Notice of Allowability

09/380,351

EDDY ET AL.

EXAMINER'S AMENDMENT

FIG. 1

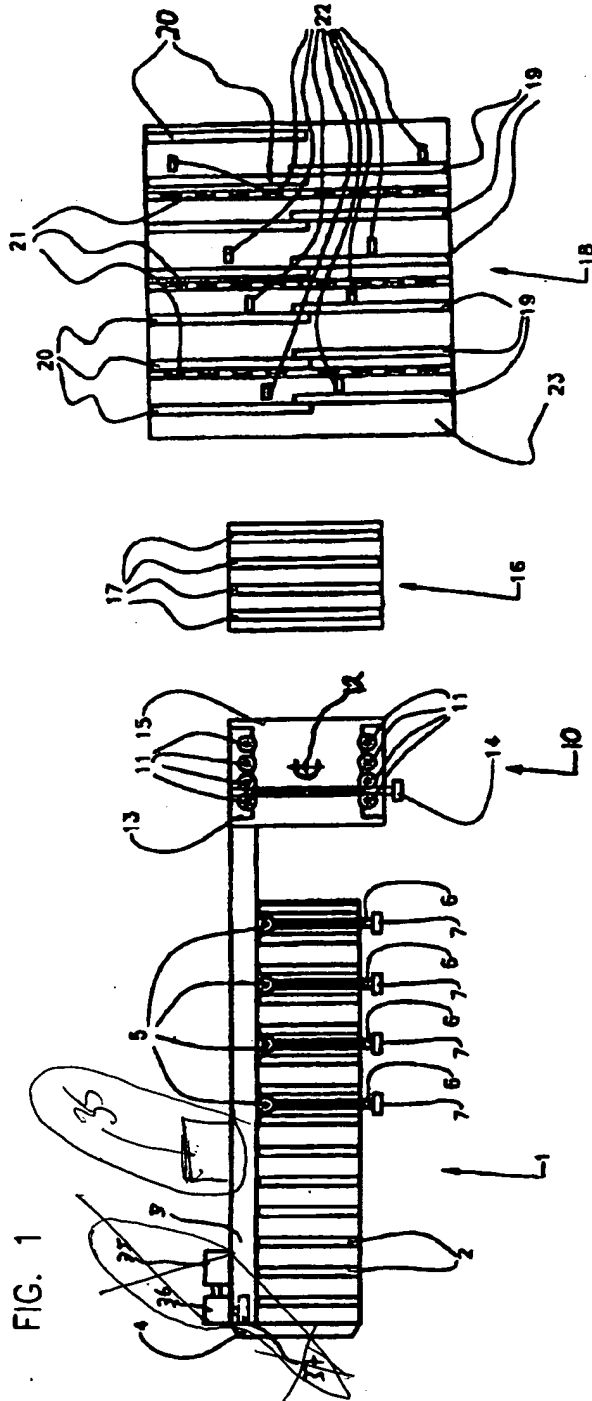
In Figures 1 and 3, the added structure including numerals 35, 36, 37 and the specific structure related thereto will be removed and a box indicated by numeral 35 will be added as shown in the approved marked-up drawings included herewith.

In order to avoid abandonment of the application, applicant must make these above agreed upon drawing changes.
